# Access Compliance Report

## Public Rights-of-Way

Intersection ID: 5058	Main Street: KILLARNEY_PL	Cross Street: MORNING_GLORY_DR	Location: E
ADA ID: 2040C7B13D3D	Ramp Type: Perp	Initial Pass/Fail: Fail	Overall Compliance: No
Codes/Mitigation Info/Possible Solution		Field Measurements/Component Compliance	
Severity Score: 13.75

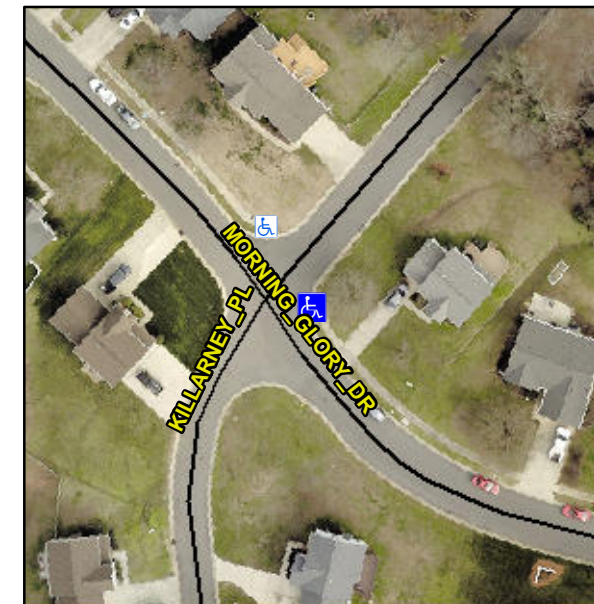
**Not Found, R304.2.2, R304.5.3**

Compliance	Description	Data	Compliance	Description	Data
N/A	Ramp Length (in)	48.0	No	Ramp Slope (%)	10.5
Yes	Ramp Width (in)	48.0	No	Ramp XSlope (%)	4.4
N/A	Flare Type LT	N/A	N/A	Flare Type RT	N/A
N/A	Flare Slope LT (%)	N/A	N/A	Flare Slope RT (%)	N/A
N/A	Flare Traversable LT?	N/A	N/A	Flare Traversable RT?	N/A
N/A	Landing Length (in)	N/A	N/A	DWS Provided?	N/A
N/A	Landing Width (in)	N/A	N/A	DWS Contrast?	N/A
N/A	Landing Slope (%)	N/A	N/A	DWS Length (in)	N/A
N/A	Landing X Slope (%)	N/A	N/A	DWS Full Width?	N/A
N/A	Landing Curb? (Y/N)	N/A	N/A	DWS Offset (in)	N/A
N/A	Shared Landing?	N/A			
N/A	Gutter Ponding?	N/A	N/A	Gutter Slope (%)	N/A
N/A	Gutter Lip Ht (in)	N/A	N/A	Gutter X Slope (%)	N/A
N/A	Painted X Walk1?	No	N/A	Painted X Walk2?	N/A
	X Walk 1 Direction	To NW		X Walk 2 Direction	N/A
N/A	X Walk 1 Width (in)	N/A	N/A	X Walk 2 Width (in)	N/A
	X Walk 1 Slope (%)	4.2		X Walk 2 Slope (%)	N/A
	X Walk 1 X Slope (%)	2.2		X Walk 2 X Slope (%)	N/A

**Remove & Replace Entire Ramp.**
